DESIGN CP	DRAWN BY CP	DART AEROSPACE LTD HAWKESBURY, ONTARIO, CANADA	
CHECKED [Signature]	APPROVED [Signature]	DRAWING NO. DSI 9065	REV. C SHEET 1 OF 1
DATE 01.04.11		TITLE AS350/355 STEP INSTALLATION	SCALE NTS
A	97.05.20	NEW ISSUE	
B	98.11.23	NON-SPECIFIC BOLT ADDED	
C	01.04.11	REMOVED SPACERS

DART SERVICE INSTRUCTION

TO AMEND INSTALLATION DRAWING D350-591 REV D
REF. CANADIAN STA: SH92-6
REF. FAA STC: SH967NE

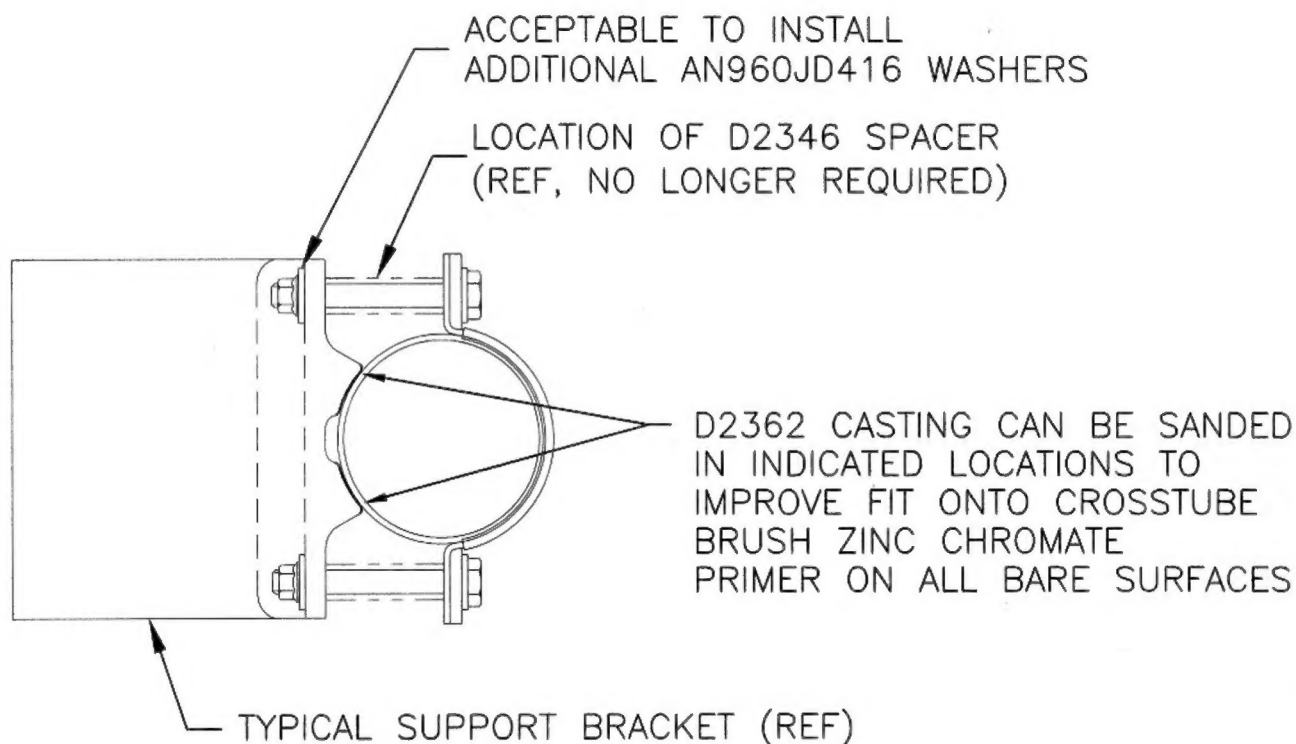
FOR THE D350-591-111/-111A/-113/-115/-117/-119
INSTALLATIONS, THE D2346 SPACERS ARE NO LONGER REQUIRED.
LONGER OR SHORTER AN4 BOLTS MAY BE SUBSTITUTED OR
ADDITIONAL AN960JD416 WASHERS CAN BE INSTALLED UNDER THE NUT
TO ENSURE 1.5-4 THREADS IN SAFETY.
